WOODLAND COMMUNITY COLLEGE
Woodland, California

ADDENDUM # 3 Date: December 20, 2021

WOODLAND COMMUNITY COLLEGE
PERFORMING ARTS/
CULINARY SERVICES
FACILITY
2300 E. GIBSON RD., WOODLAND, CA 95776
YUBA COMMUNITY COLLEGE DISTRICT

drawing title:
SLAB PLAN - OVERALL

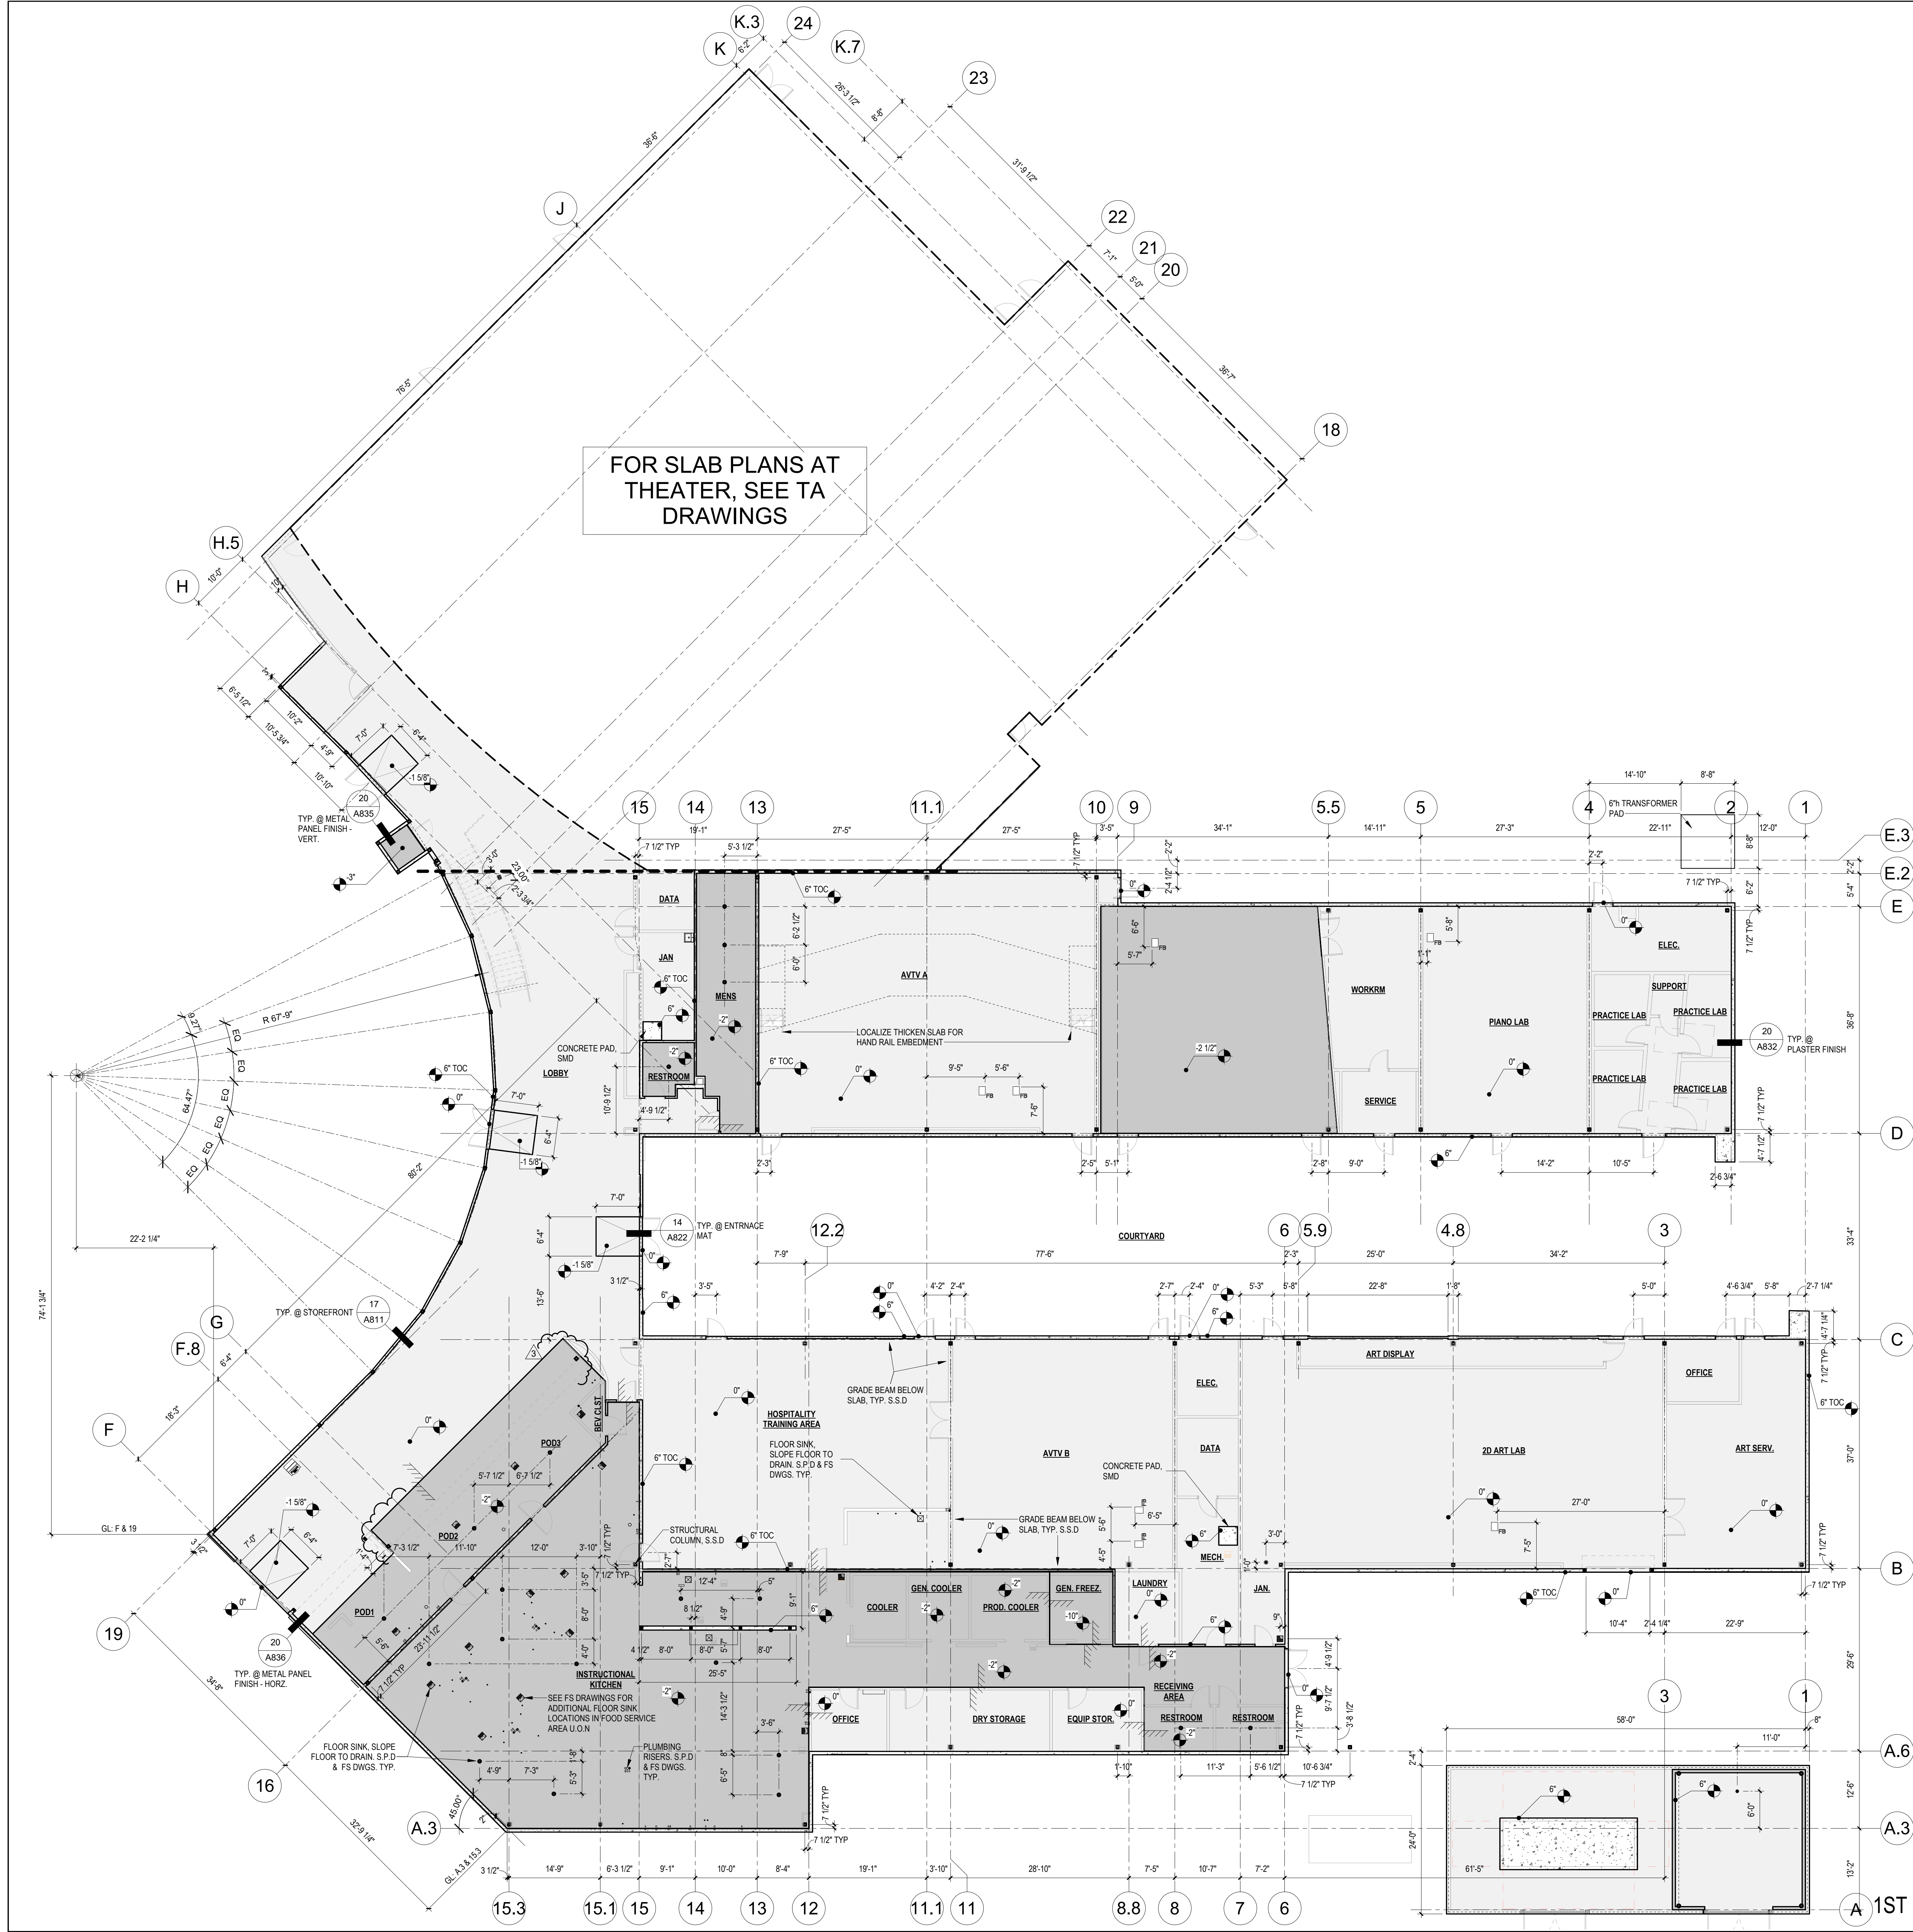
- A100** – Coordinate depress slab edge to match the finish product
- A262** – Added metal trim notes
- A611** – Finish Schedule Legend
 - Update finish legend
- A621** – Remove door 960 from this sheet (duplicated from TA701)
- TA701** – Remove duplicated Exterior Doors 964A, 964B, 964Da (duplicated from A621). Provided door material type.

DOOR SCHEDULES

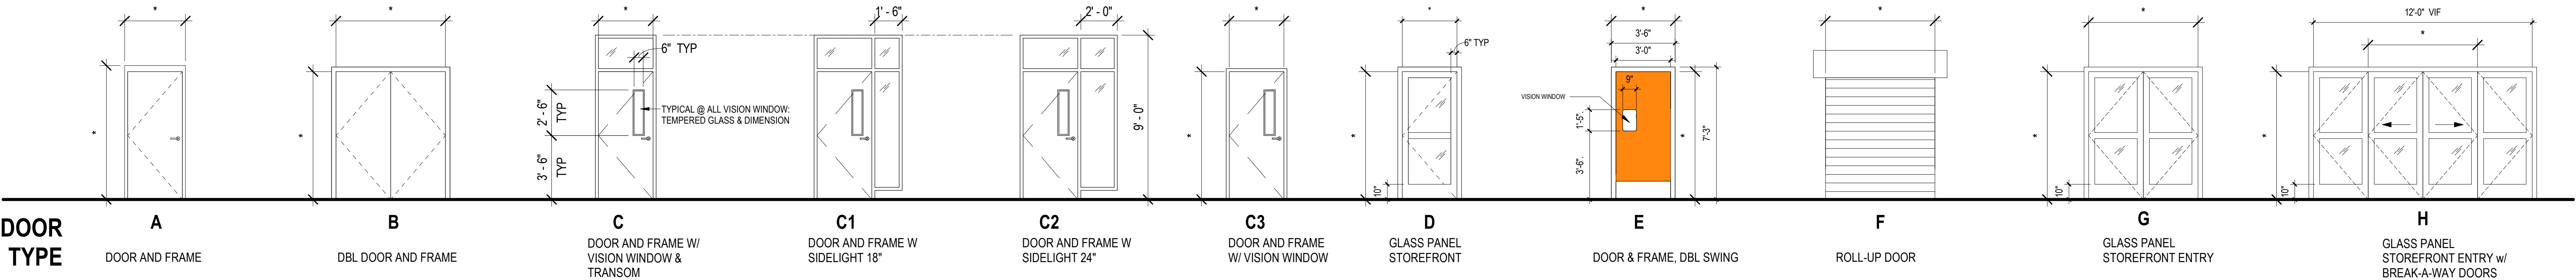
20.Doors: Sheet A611 shows door types C, C1 and C2 as aluminum with factory finish. The door legend on the same sheet shows these as flush doors with vision lights. Please confirm the material for these doors.	tBP	These door shall be aluminum w/ factory finish and vision lite as shown (08 41 13)

drawing title:
DOOR & WINDOW
SCHEDULE, ELEVATIONS

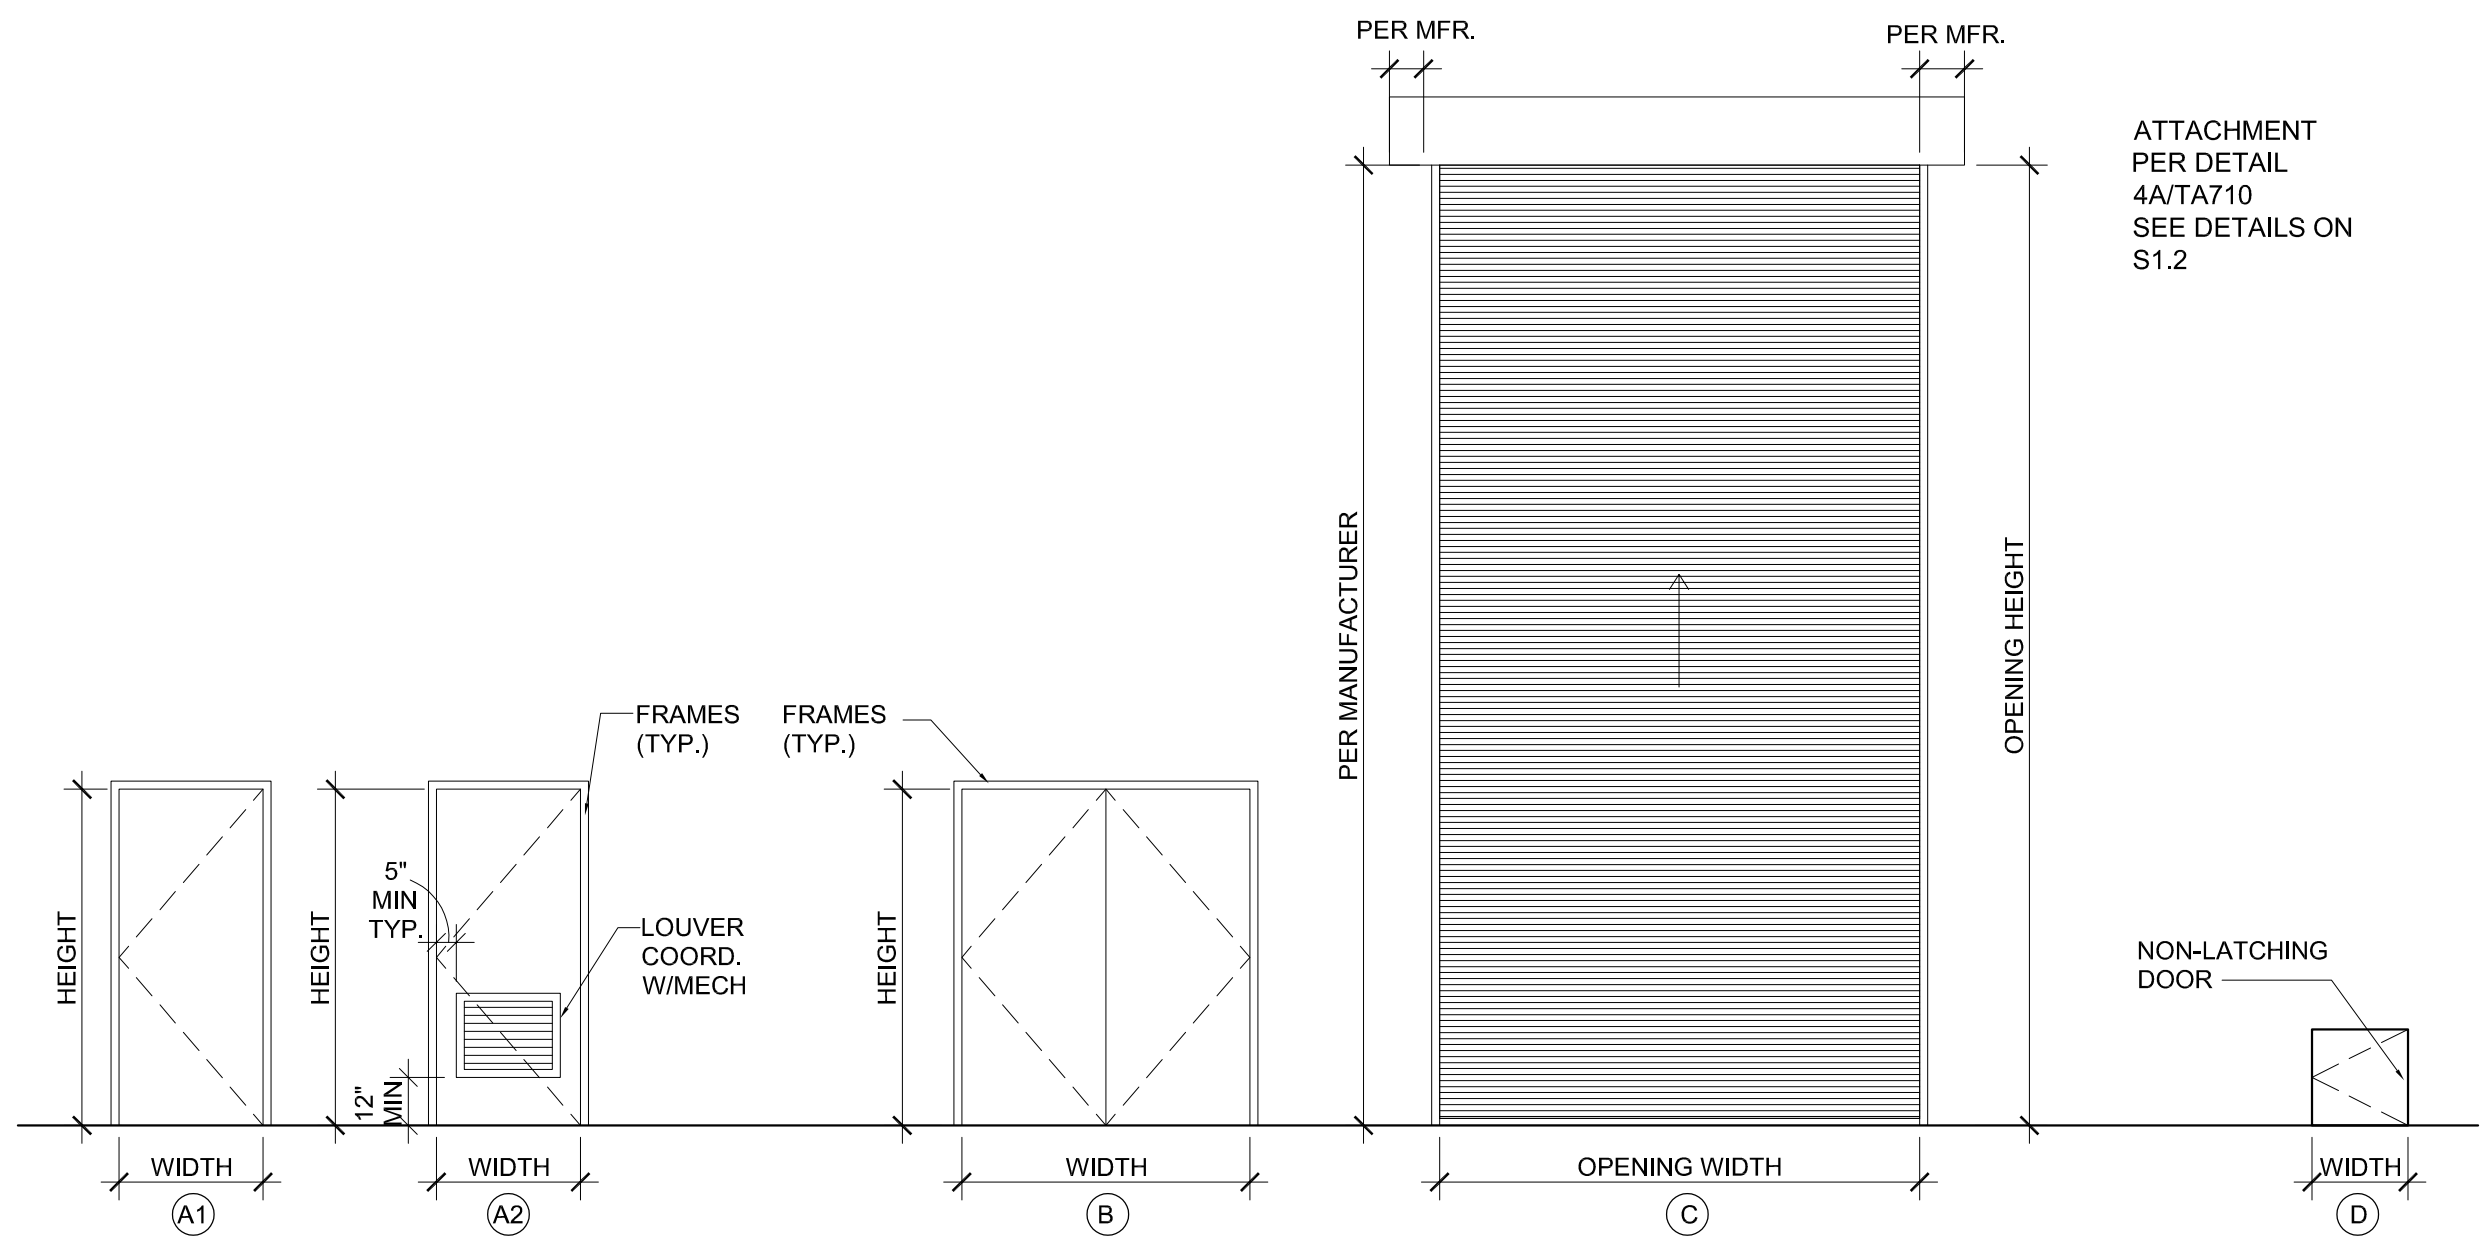
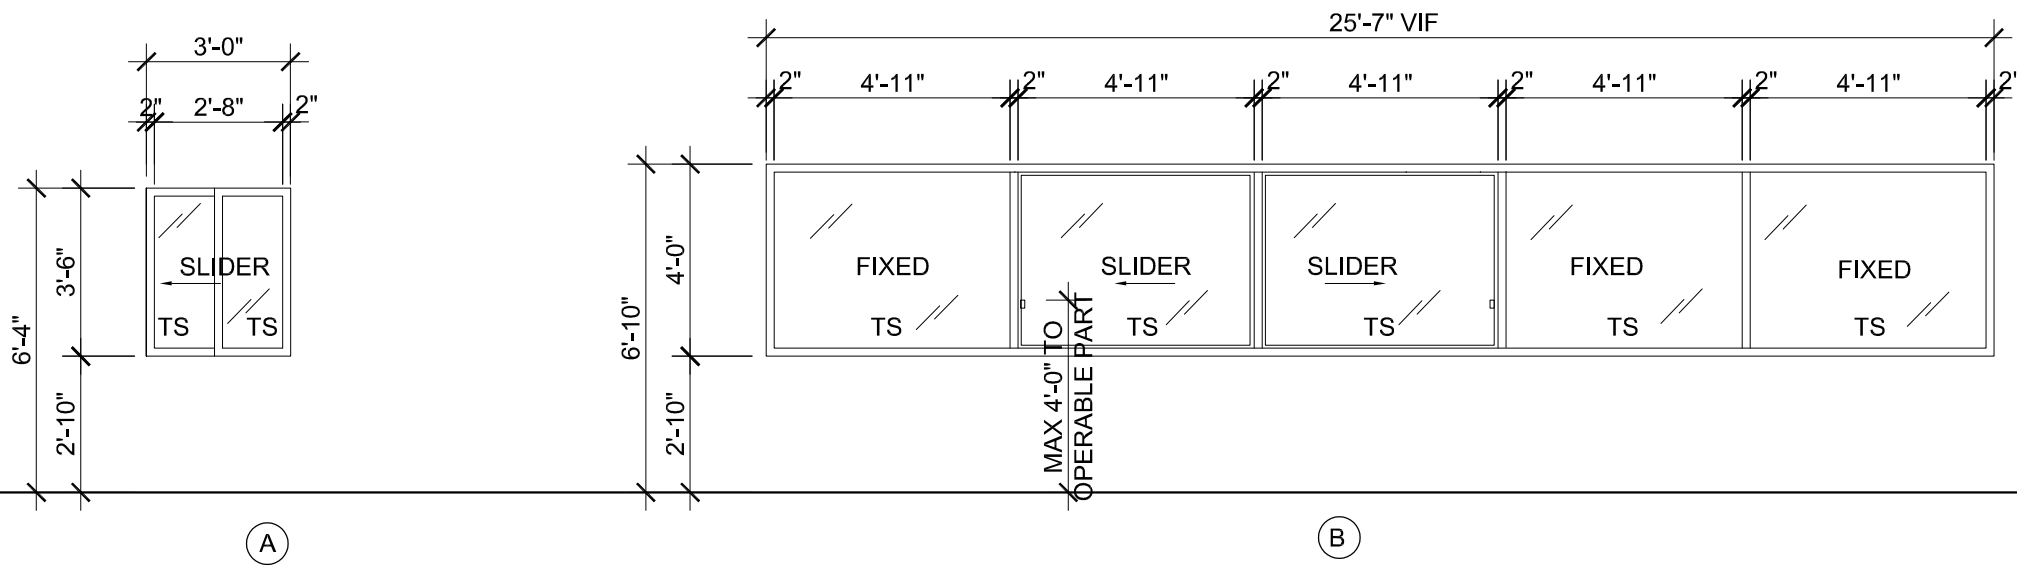
28.Doors: Per door schedule TA701, the door material column is blank for all doors listed. Please provide material information for these.	JSFA	see Addendum #3
12/13/21	Point 1
